SERVICE INFORMATION LETTER

Subject: IGVA Sector Gear with Oversize D-Hole Creating Loose Fit with NHA

Figure 1, Sector Gear, Showing Oversize D-Shaped Hole

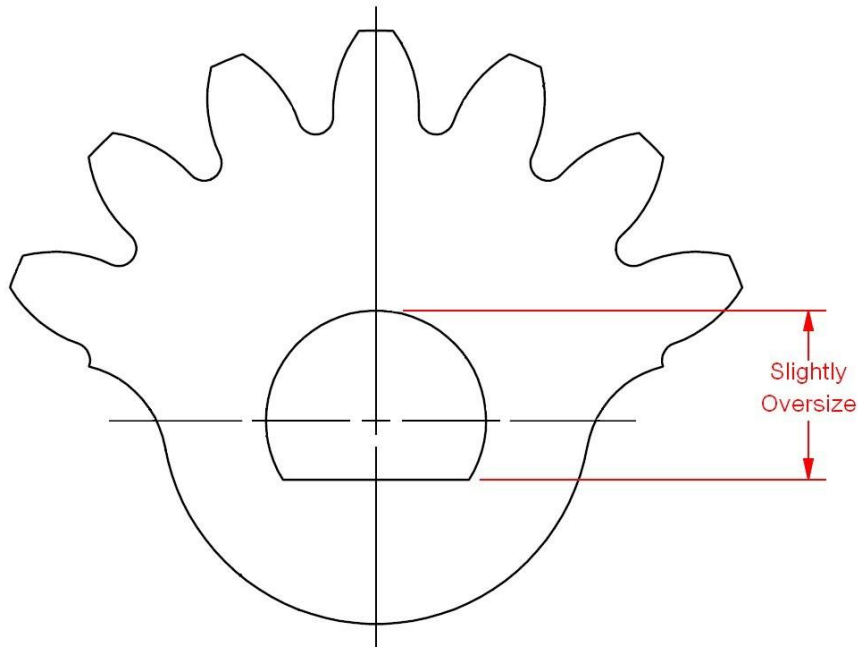
The D-shaped hole in the Wencor Inlet Guide Vane Assembly Sector Gear PN 3810119-2WE was manufactured oversize by .002” as shown below in Figure 1. The oversize condition will create a loose fit with the mating part and may lead to premature wear on the Inlet Guide Vane (IGV) stem, or other IGVA parts that operate in conjunction with the Sector Gear (see Figure 2).

Based upon a customer report of a tight installation problem, Wencor revised the Sector Gear design by adjusting the maximum D-shaped hole size up by .002" to prevent a possible interference condition with the mating IGV Vane stem. It was later discovered that the IGV Vane stem was the cause of the interference condition and the D-shaped hole size was re-designed larger than allowed per the OEM CMM. The re-designed Sector Gears were sold to customers and put into service.

The size of the Wencor Sector Gear D-shaped hole has subsequently been revised and is now equivalent to the OEM hole size limits. All Wencor Sector Gears purchased after July 2012 have the correct D-shaped hole size.

For new Wencor Sector Gears that have not been installed, users can verify correct D-shaped hole size by measuring the hole as described in the OEM Component Maintenance Manual (CMM). Any Wencor Sector Gear D-shaped hole that is measured oversize shall be returned to Wencor for replacement.

For Wencor Sector Gears that have been installed, the user shall check the size of the D-shaped hole at the next shop maintenance/overhaul opportunity. Any Wencor Sector Gears that are within CMM limits can remain in service and any that are out of limits shall be removed and replaced according to the CMM.
